## GENERAL APPLICATION

Location Address: 2200 MADISON STREET

**SUBJECT:** Site Plan review for a 12 unit residential development (Madison Apartments).

LANDSCAPE  
PLANTING PLAN

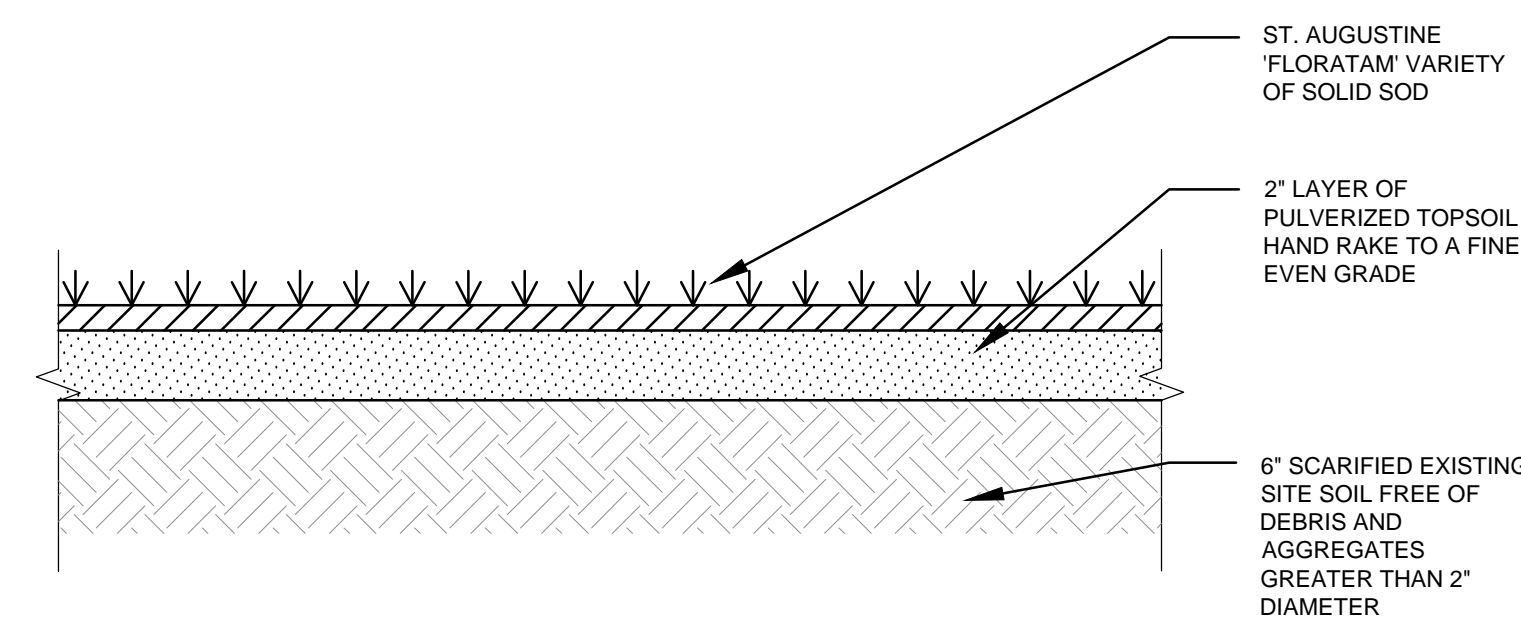
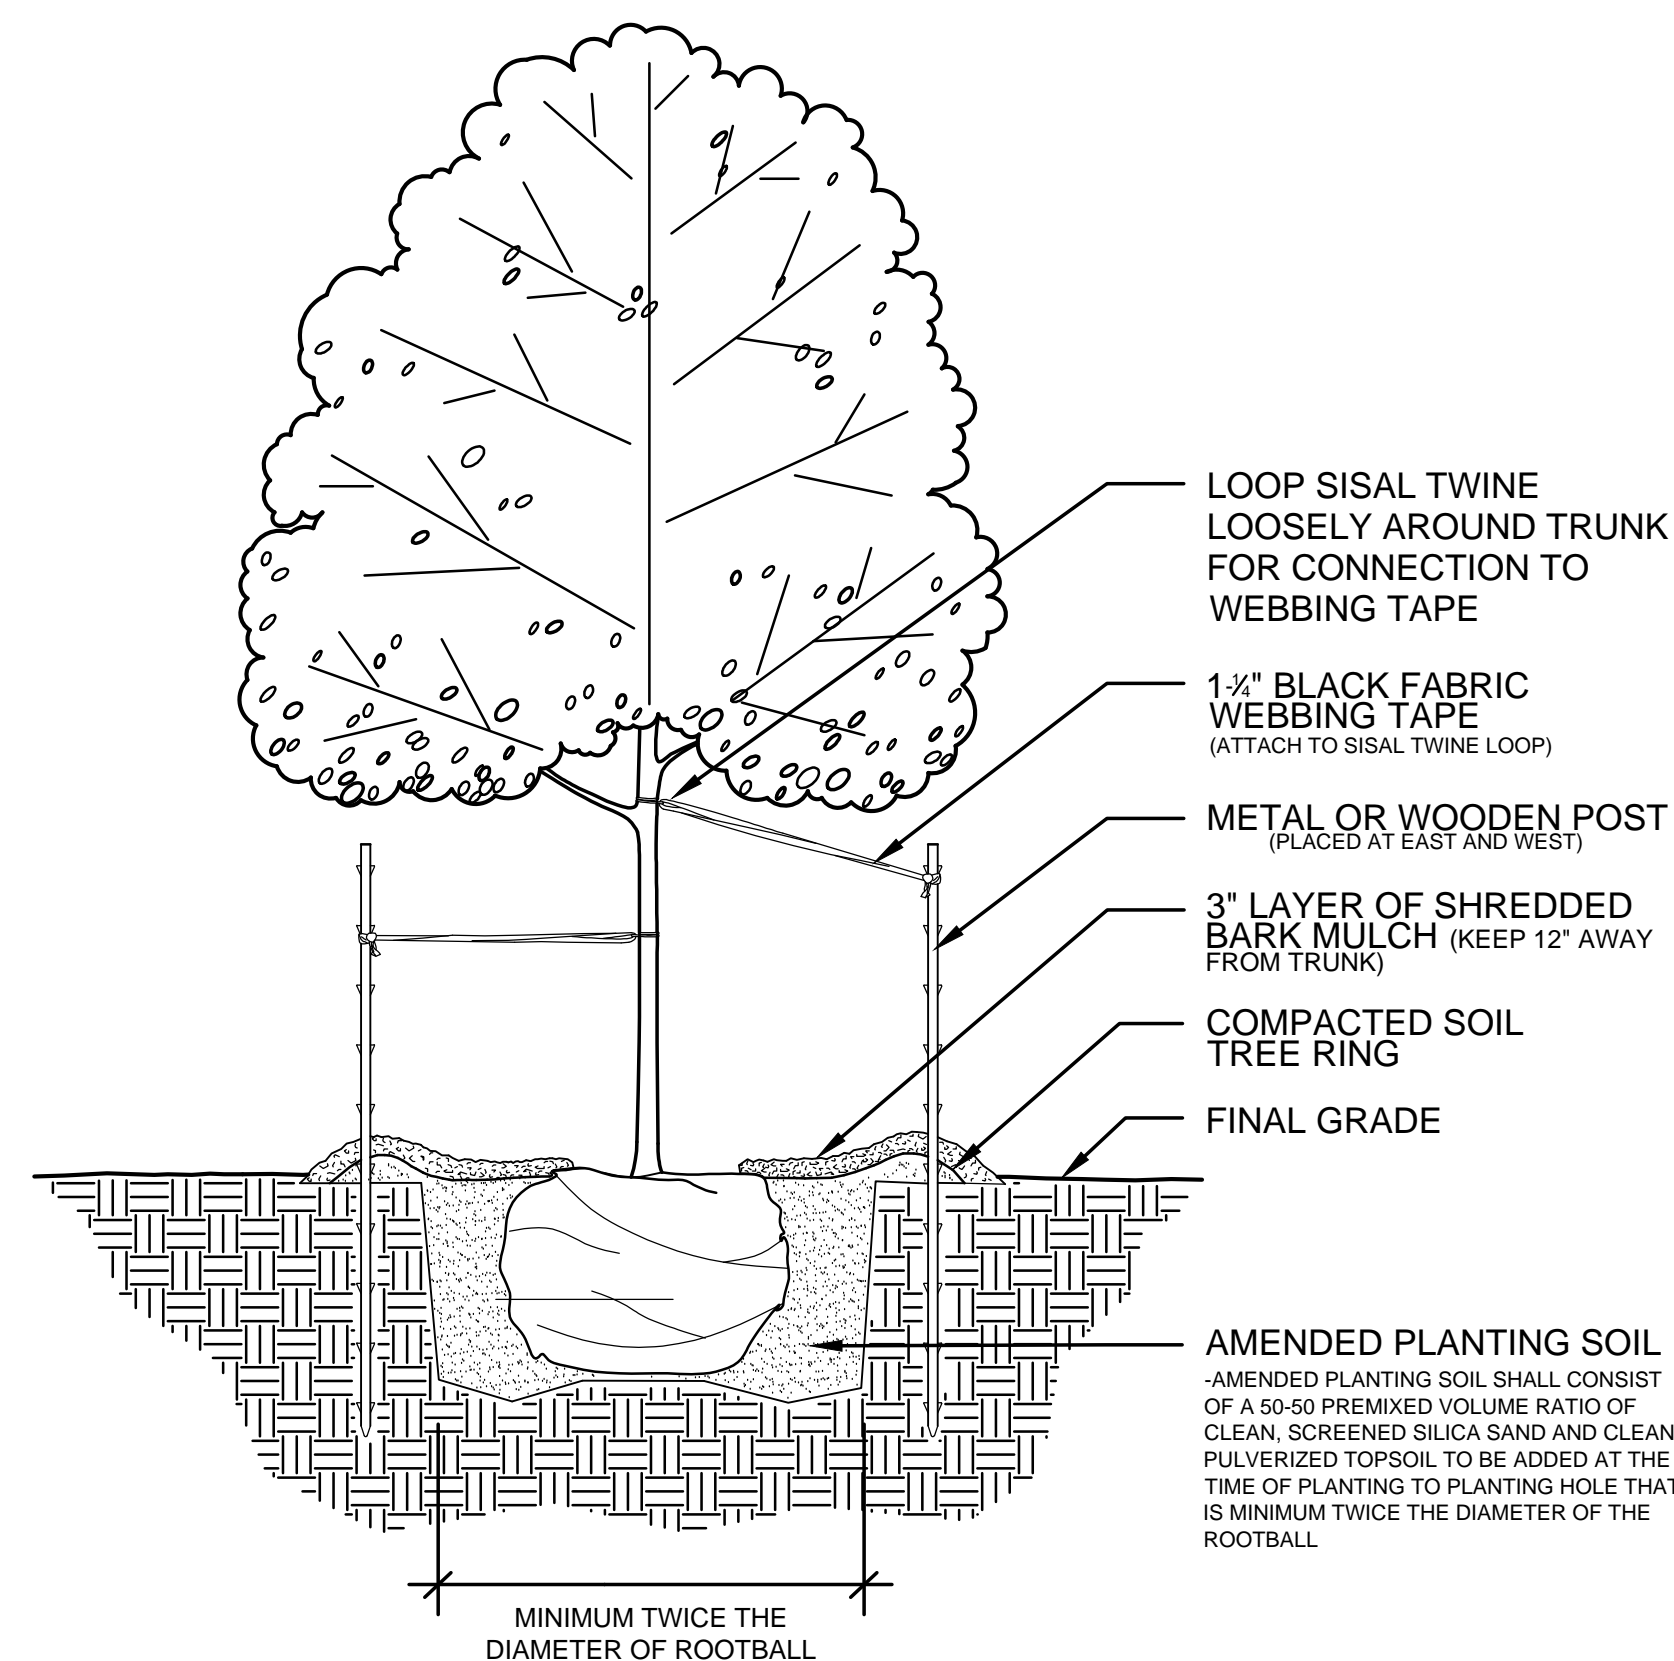
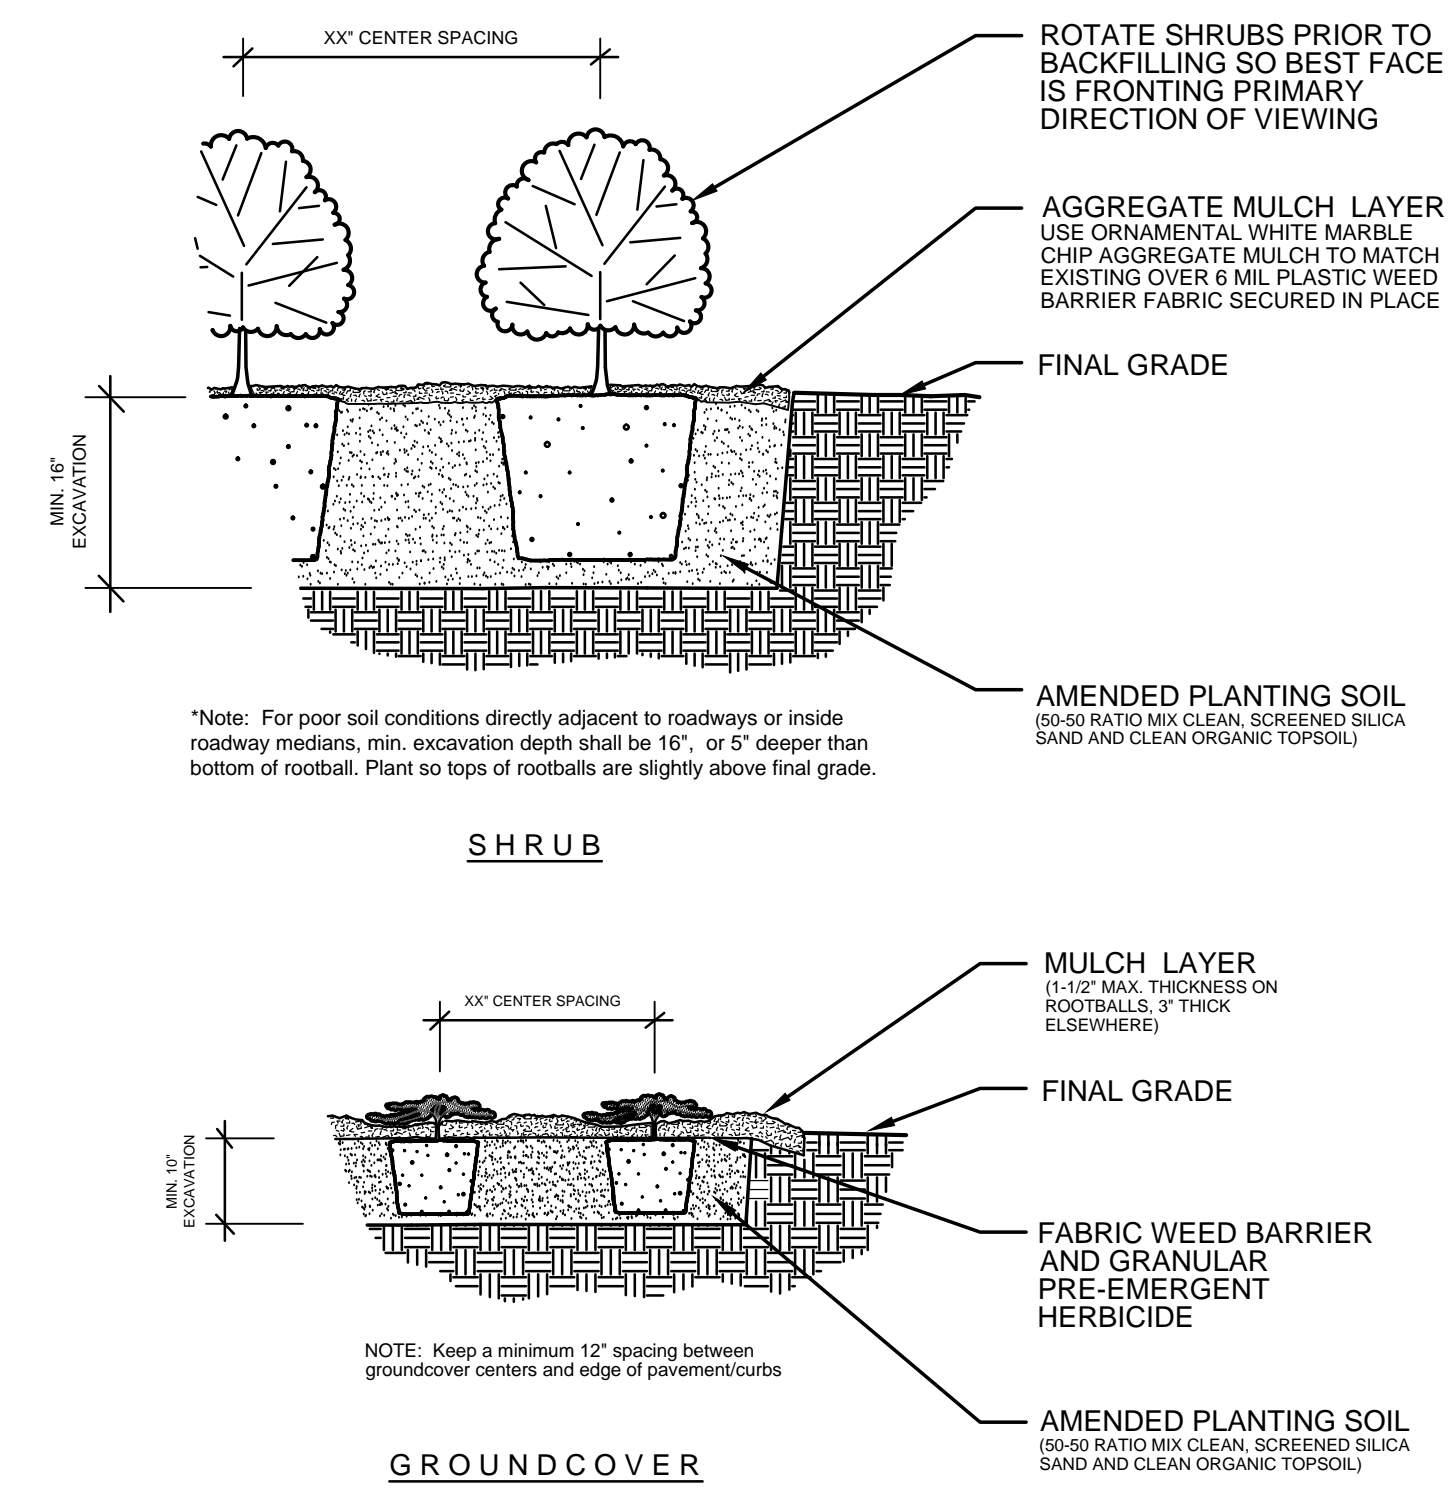
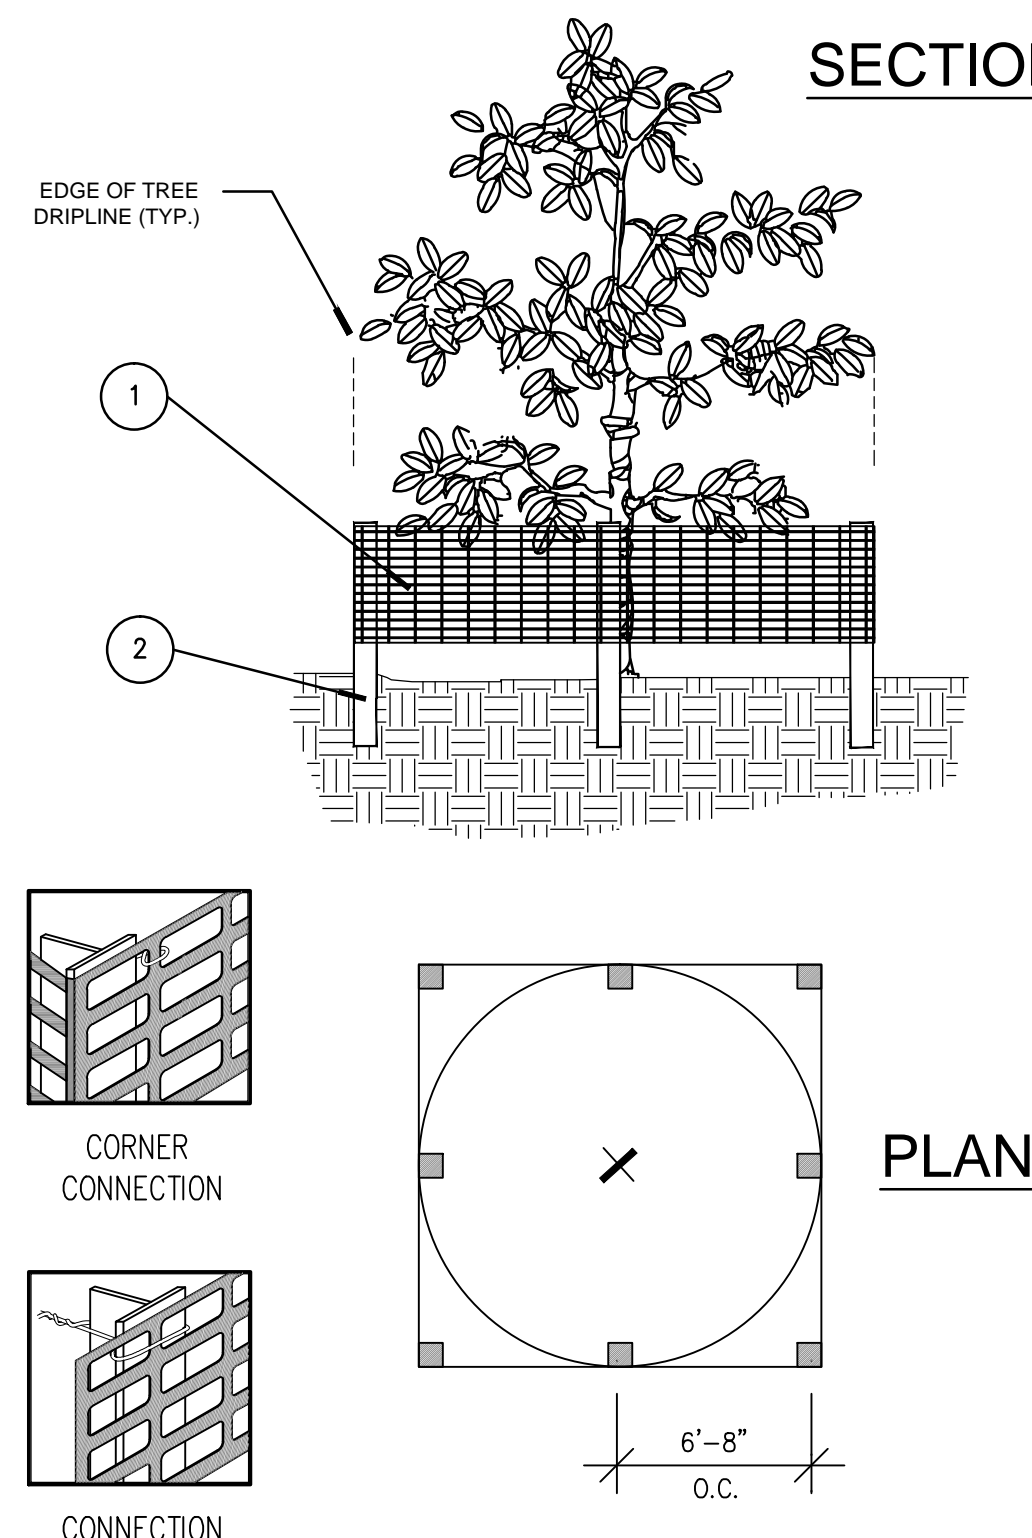
1. Provide a detailed landscape plan by a Landscape Architect that complies with all the requirements according to City of Hollywood Landscape manual, chapter 155.52, Article 9 LDR and section 6 landscape Plan details and specifications for technical review process. Landscape plan set to include and clarify what is been provided as per city code requirements for landscape for project zone type and any trees of compensation or mitigation if any trees are to be removed.

1. Provide information for existing trees on site including location, species, estimated ht./spread, and caliper diameter of trunks

2. Provide a detailed tree disposition plan in separate (if any trees to be removed) and landscape plan by a registered professional licensed Landscape Architect in the State of Florida that compliments the building architecture and uses, provides for shade, beautifies the site, accentuates site features, and serves as a buffer where appropriate. Provide tabular data chart on plan that identifies City of Hollywood landscape requirements and how they are being met for Perimeter landscape, Interior landscape for at grade parking lots and vehicular use areas, open space, view triangle, planning and development board and historic preservation board and irrigation.
